**CITY OF LOUISVILLE
STARK COUNTY, OHIO**

METZGER PARK BASEBALL & SOFTBALL FIELDS

ADDENDUM #4

September 25, 2023

FENCE DETAIL

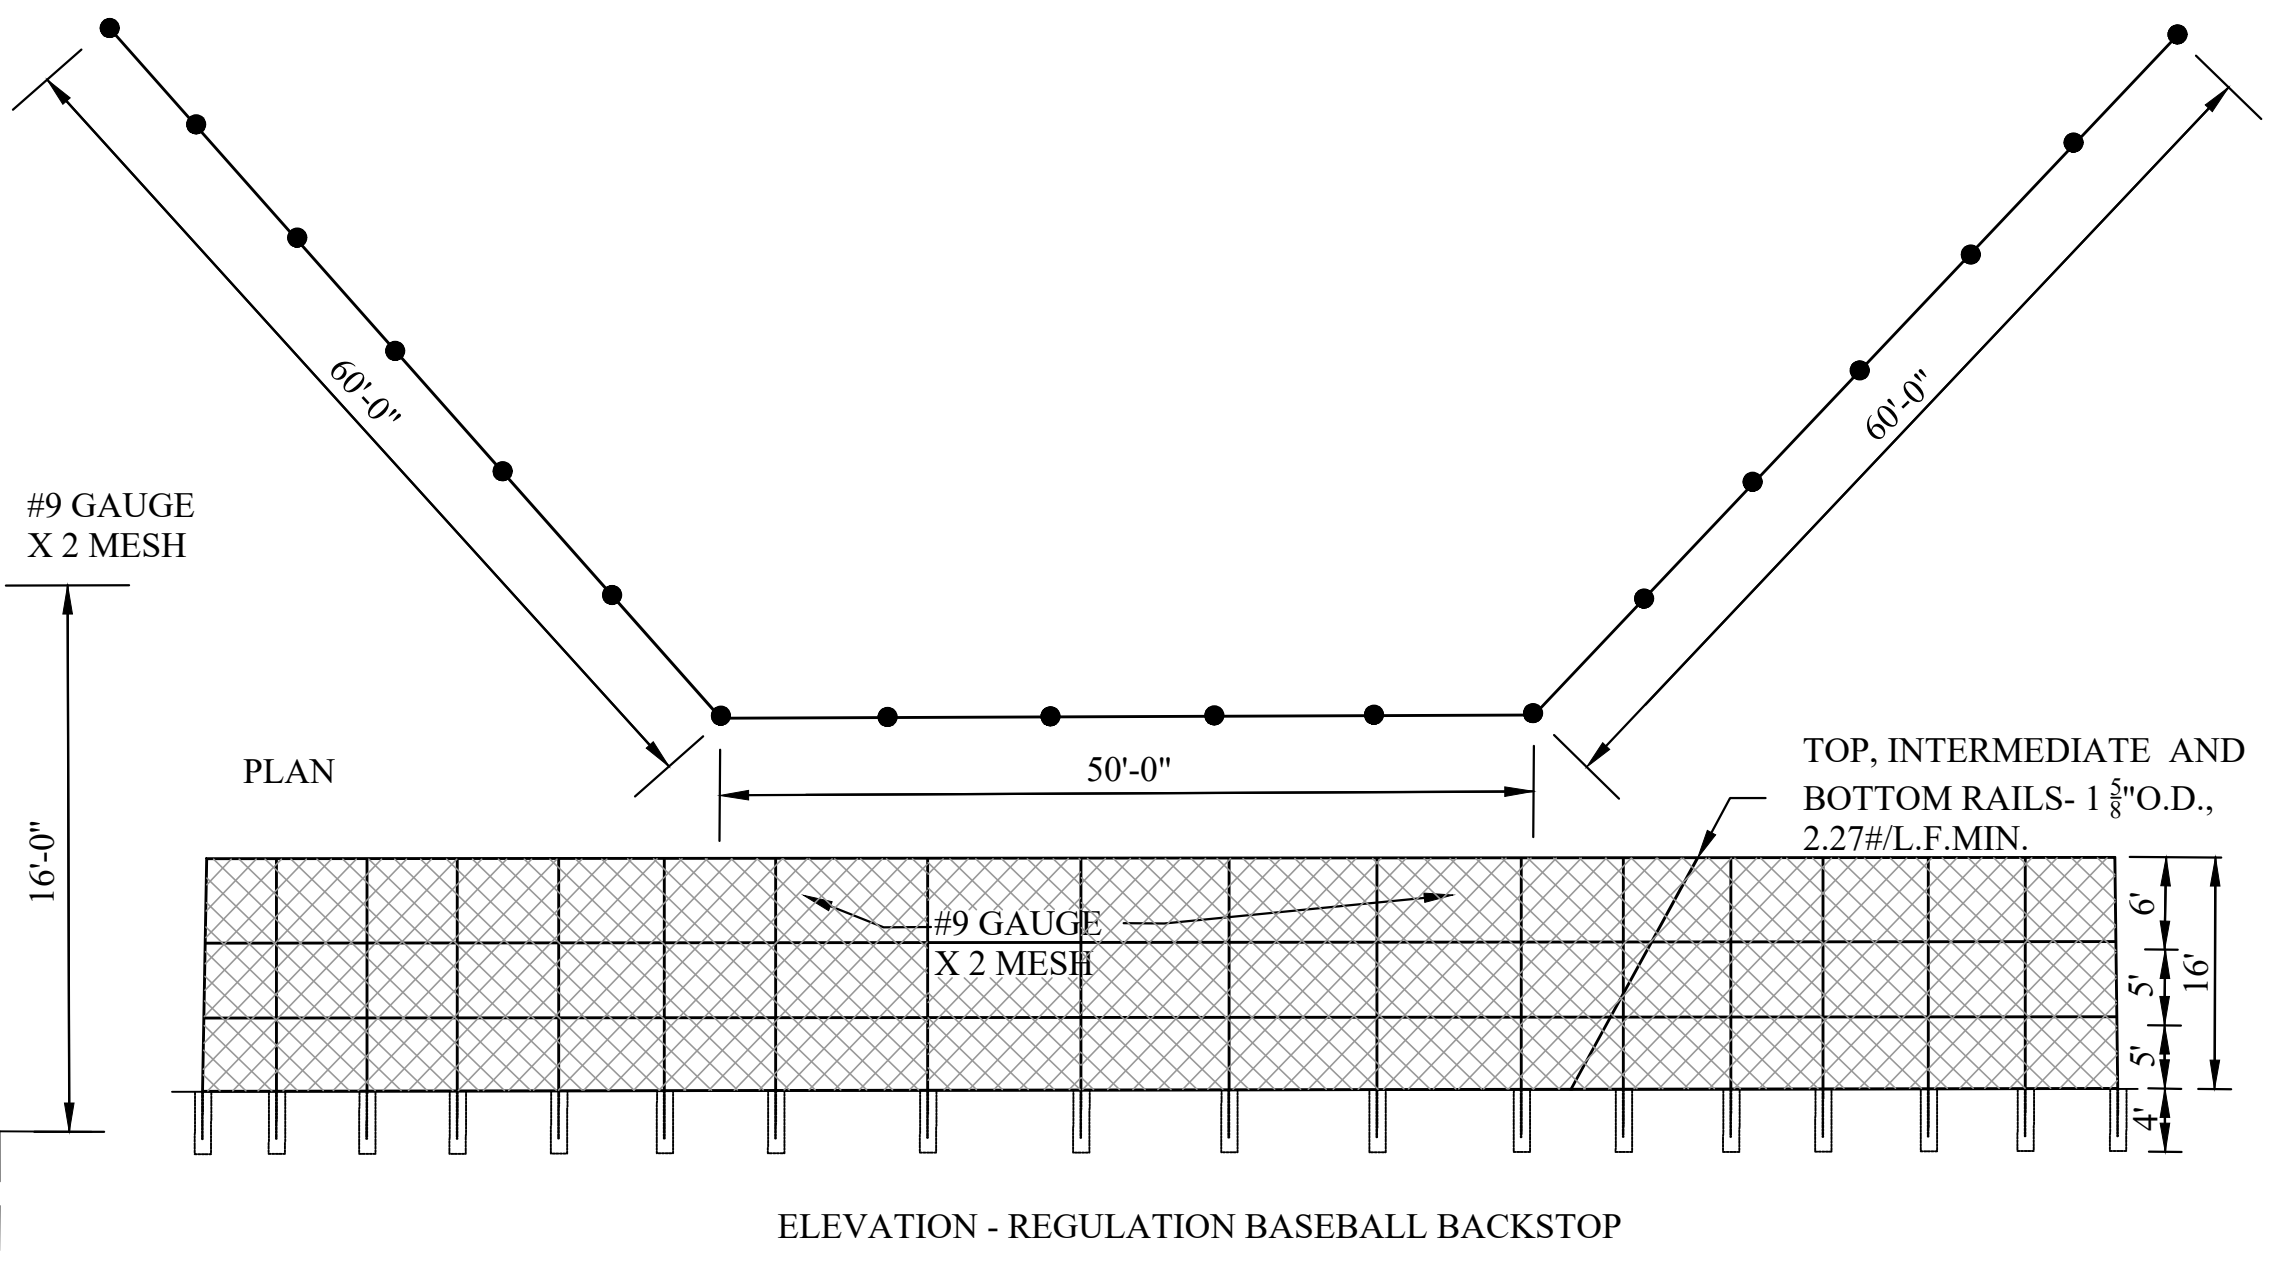
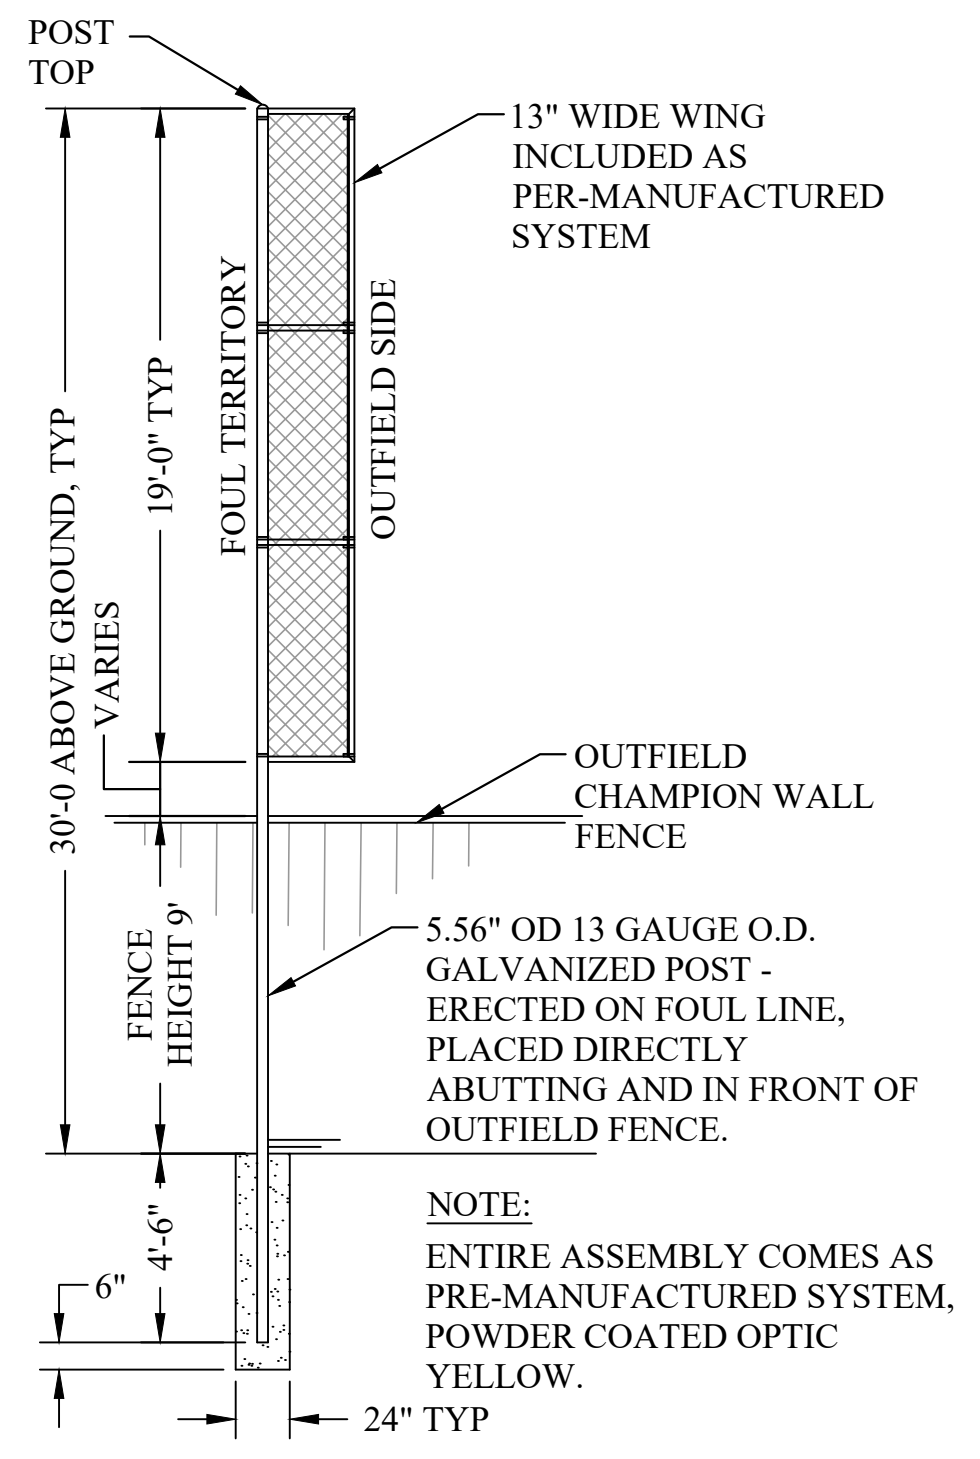
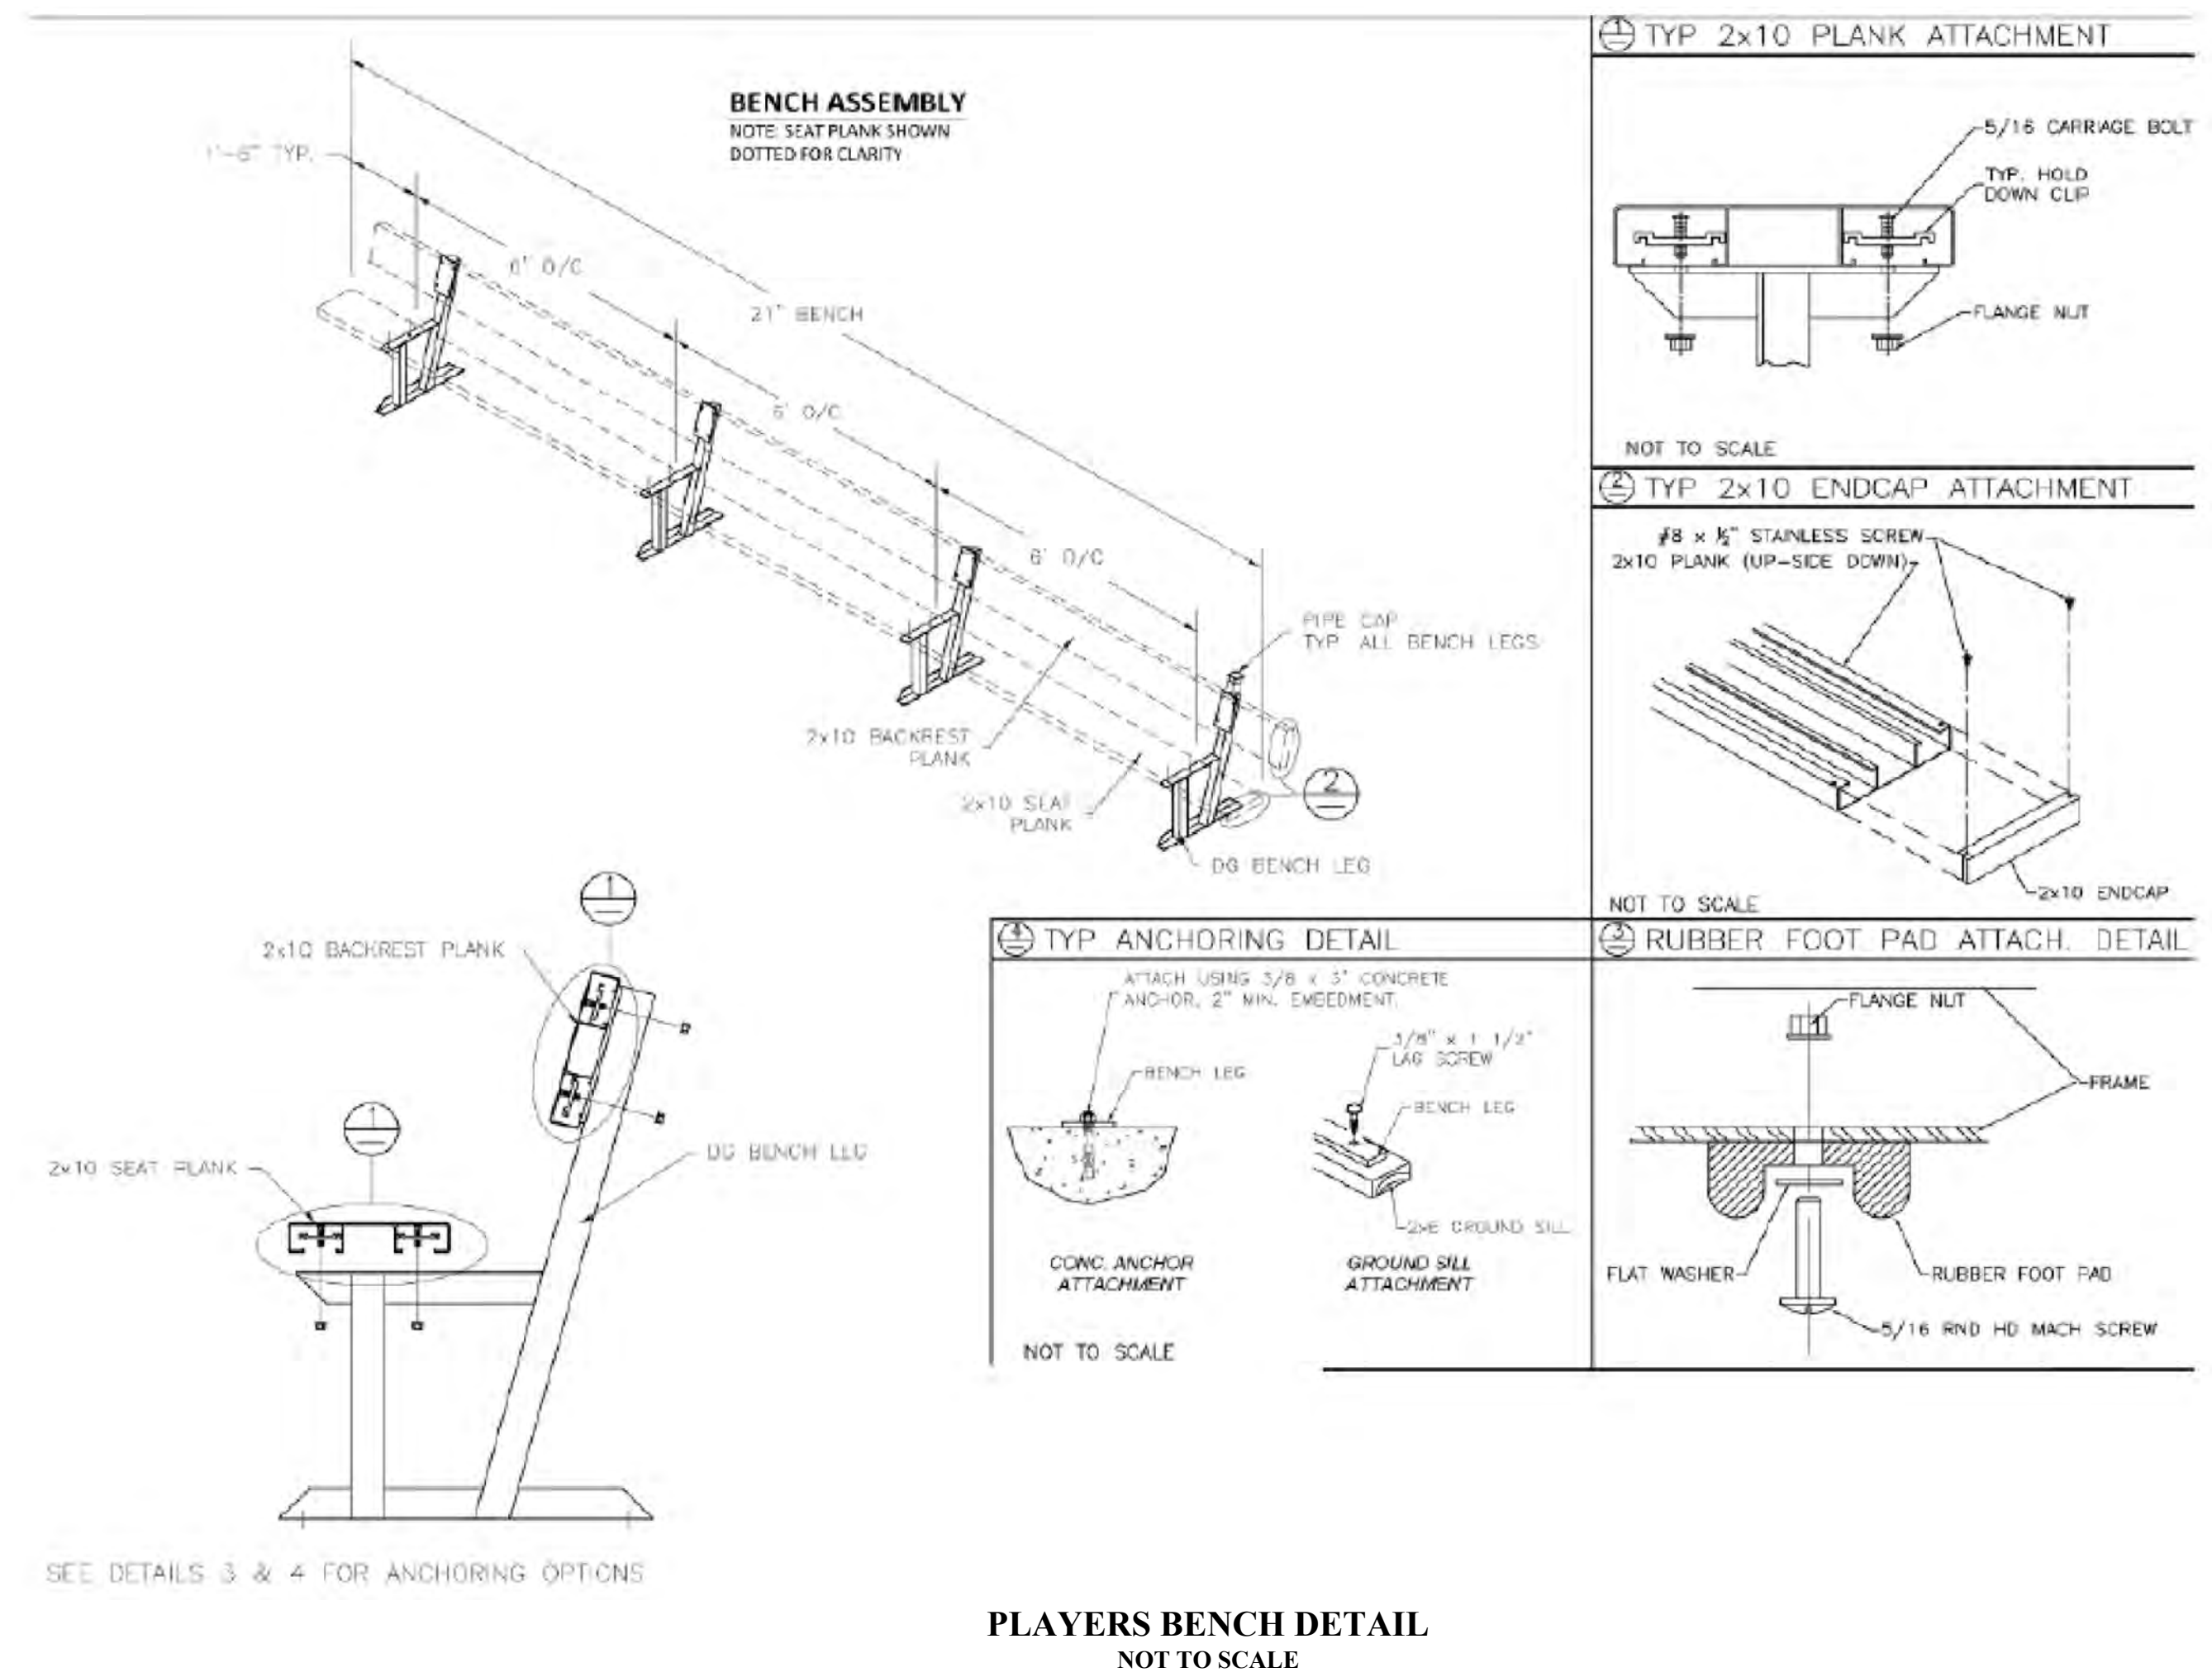
3. There are no details for the 15 ft. high fence at all. What does the owner expect for fence details here?

4. Is the backstop fence height 25 ft?

5. Is the owner's idea for an overlap on the fabric at mid height?

6. All post diameters sizes are not adequate for the height of the backstop.

7. Can we have a complete overhaul of the details on the fence for the 6 ft. sideline, 15 ft. outfield, and the 25 ft. high backstop fence?

Please refer to the revised fence detail on Sheet 26.

The backstop fence height is 15 ft. Please refer to the revised fence detail on Sheet 26.

Please refer to the fence detail on Sheet 26.

Please refer to the fence detail on Sheet 26.

Please refer to the revised fence detail on Sheet 26.
